| Project | IEEE 802.16 Broadband Wireless Access Working Group < http://ieee802.org/16 > | |
| Title | Architecture clarification and Coexistence Protocol messages cleaning | |
| Date Submitted | 2005-09-14 | |

The paper is to complete the contents, primary the T.B.D parts, proposed in IEEE C802.16h-05/011r1 which has been accepted at session#37. Moreover, clarification about the 802.16 LE network architecture is presented.

[Figure 14. Classification of 802.16 LE network architecture](#)

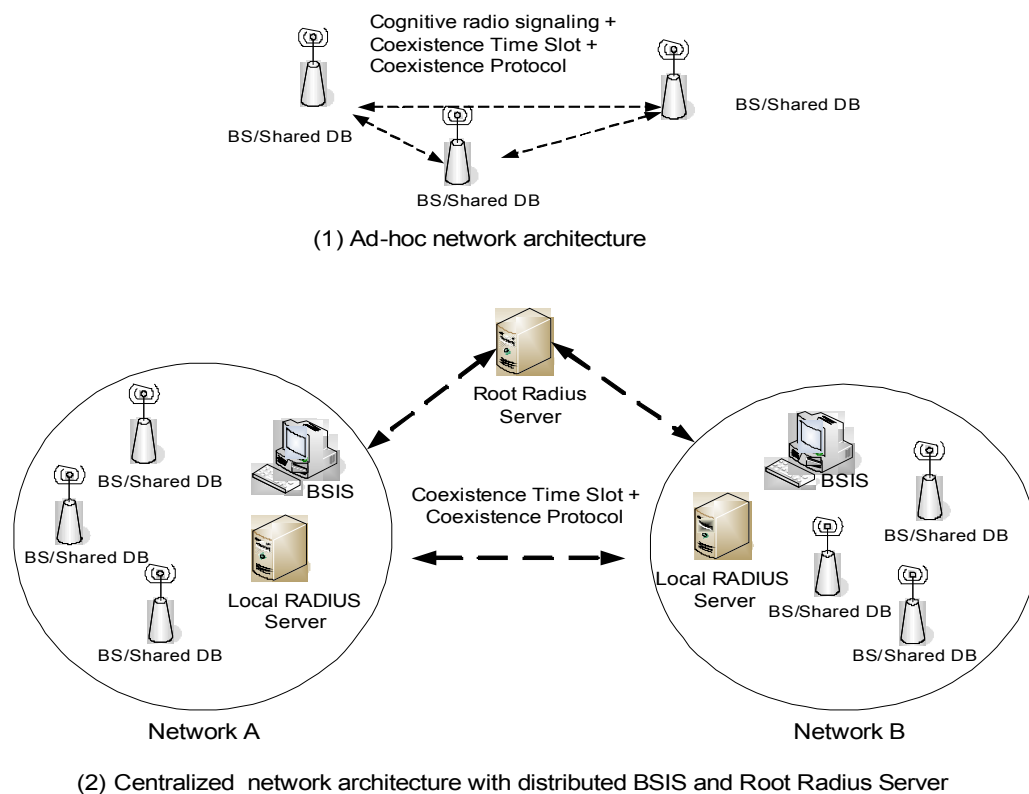
[Change Figure 14 as following]

[Figure 14 shows the classification of IEEE 802.16 LE inter-network communication architecture:](#)

Figure 12. Initialization procedures — BS

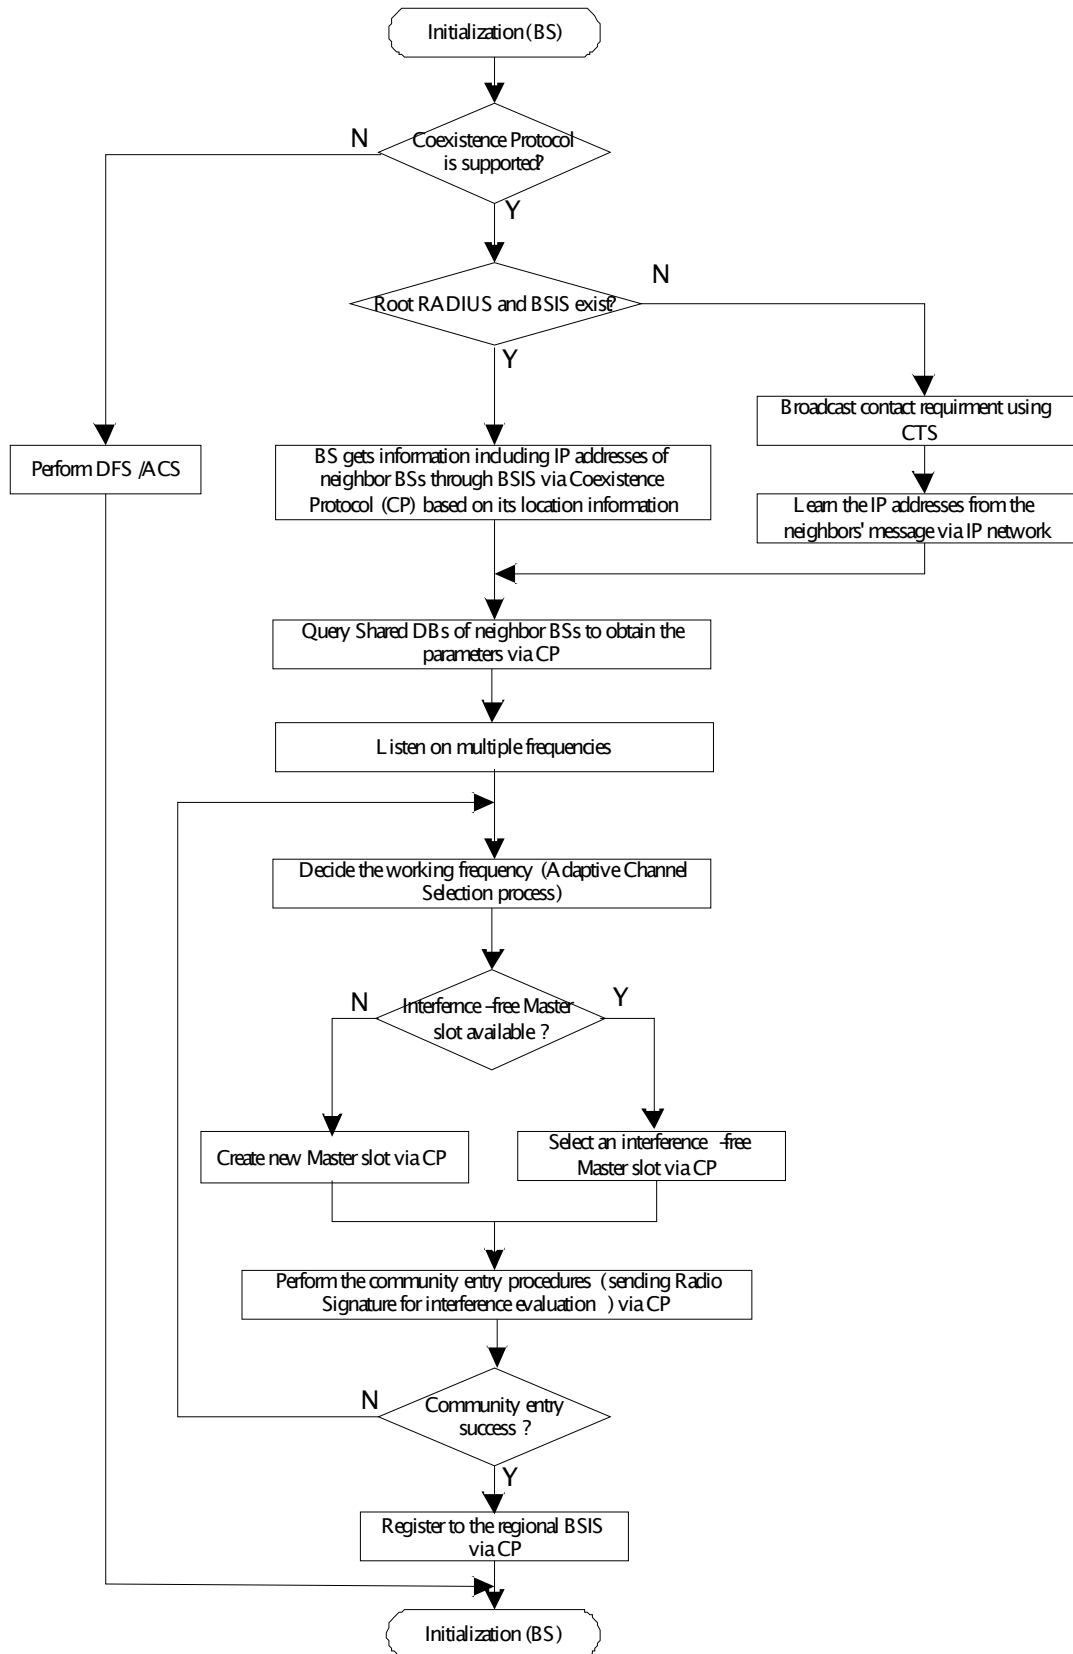
[Replace Figure 12 as following]
